OXFORDSHIRE
STRATEGIC RAIL FREIGHT INTERCHANGE

Chapter 3: Transport
Appendix 3.1: Transport Assessment Part 10 of 11

M40 J9 HIGHWAY DESIGN REVIEW

Project	**Oxfordshire Strategic Rail Freight Interchange (OxSRFI)**		
Document Number	OxSRFI-BWB-GEN-XX-RP-CH-0015	**BWB Ref**	NTH2479
Author	[redacted]	**Status**	S3
Checked		**Revision**	P01
Approved		**Date**	24.03.2026

FIGURE 1 – Location of problems identified in this audit

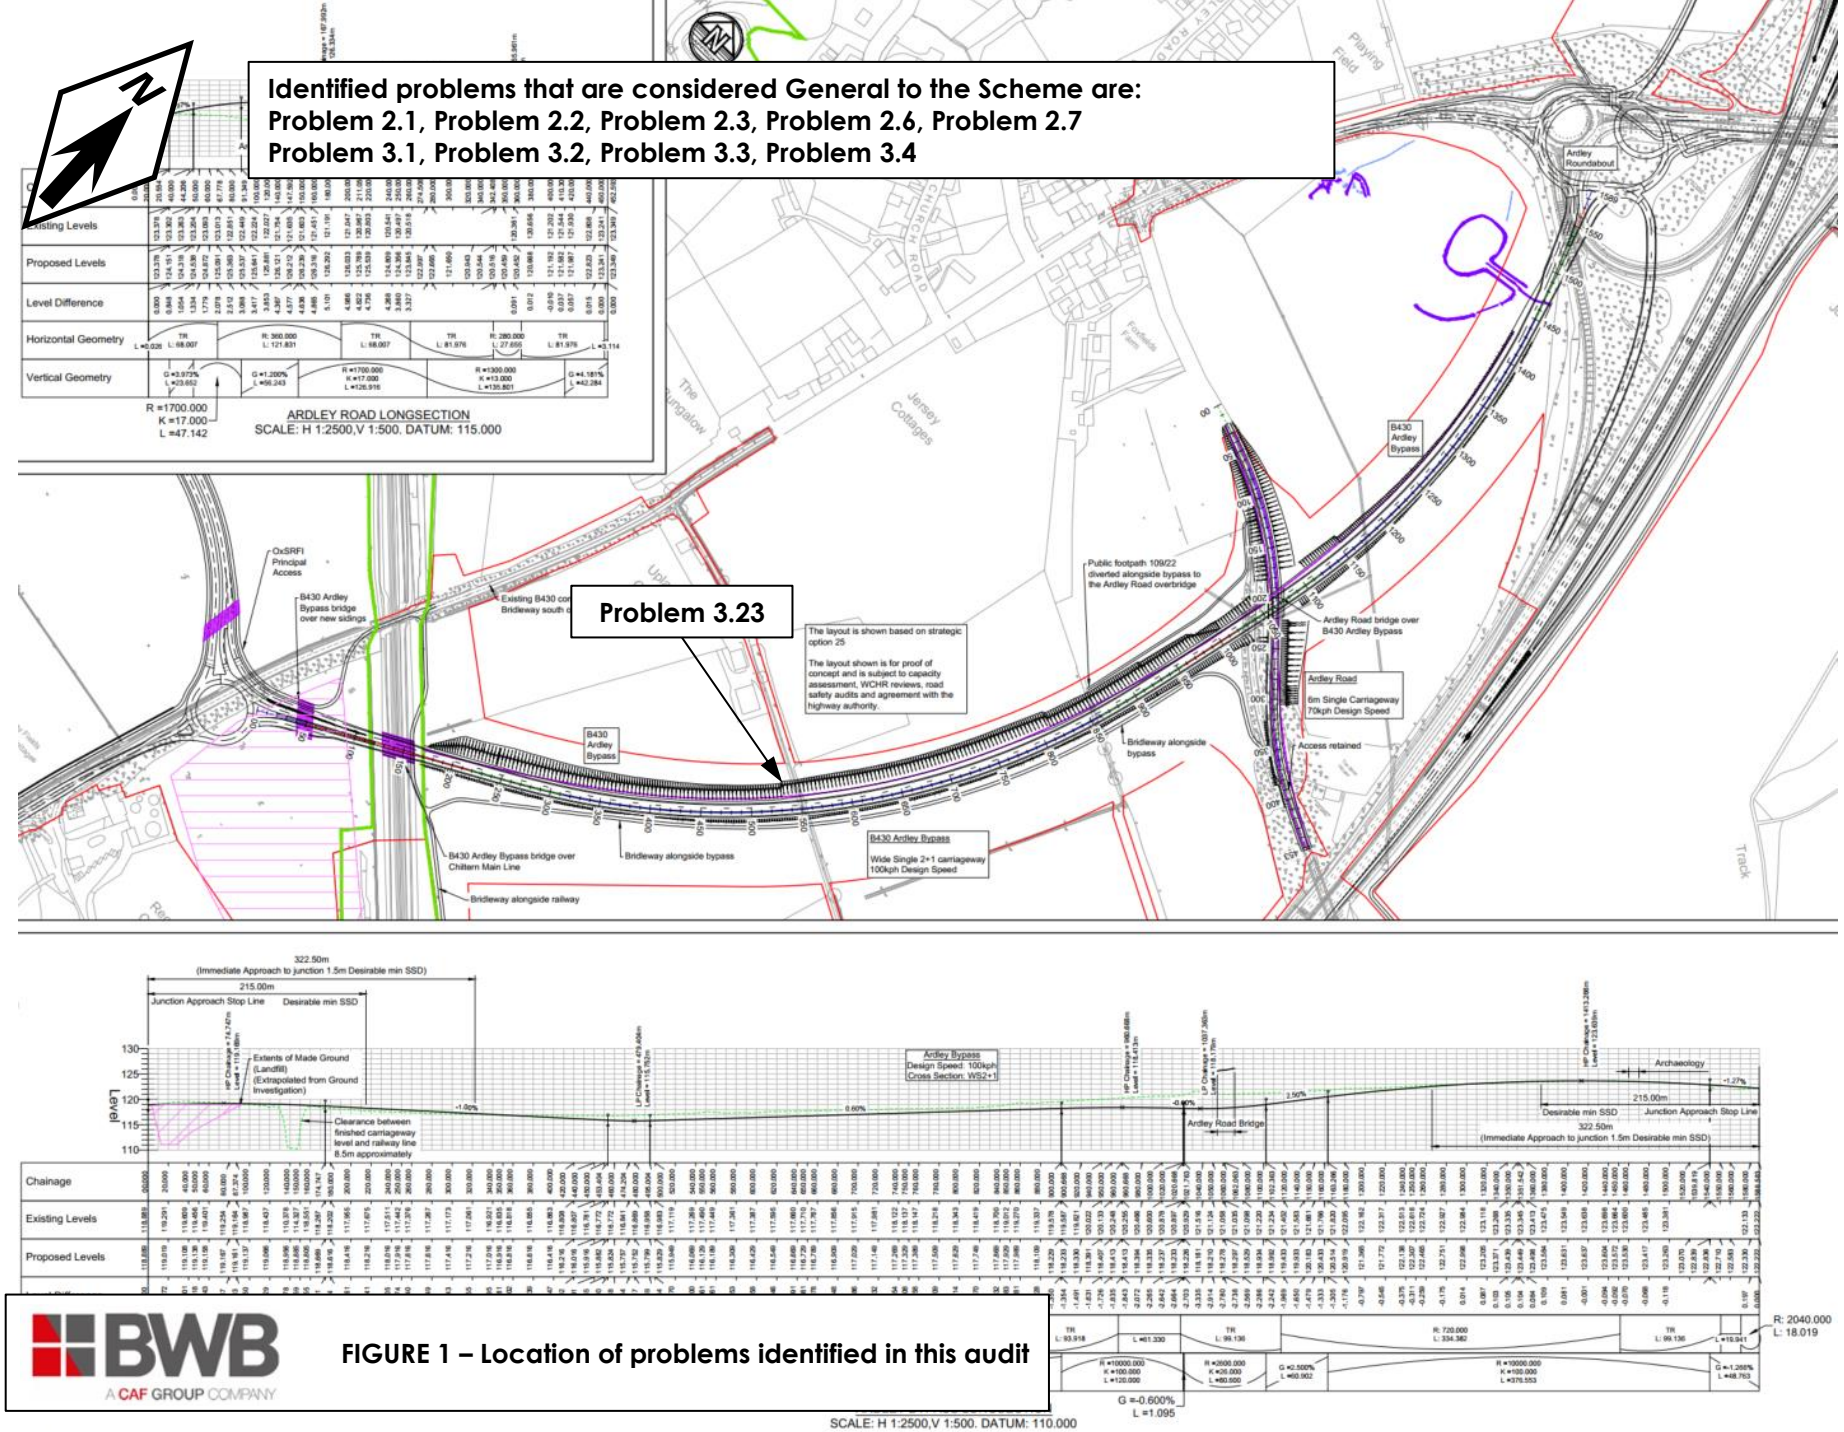
1.5 The terms of reference of the audit are as described in GG 119. The Audit Team has examined and reported only on the road safety implications of the scheme as presented and has not examined or verified the compliance of the designs to any other criteria. All comments and recommendations refer to the highway proposal drawings and the locations have been indicated on **Figure 1**.

Identified problems that are considered General to the Scheme are:
Problem 2.1, Problem 2.2, Problem 2.3, Problem 2.6, Problem 2.7
Problem 3.1, Problem 3.2, Problem 3.3, Problem 3.4

Problem 3.23
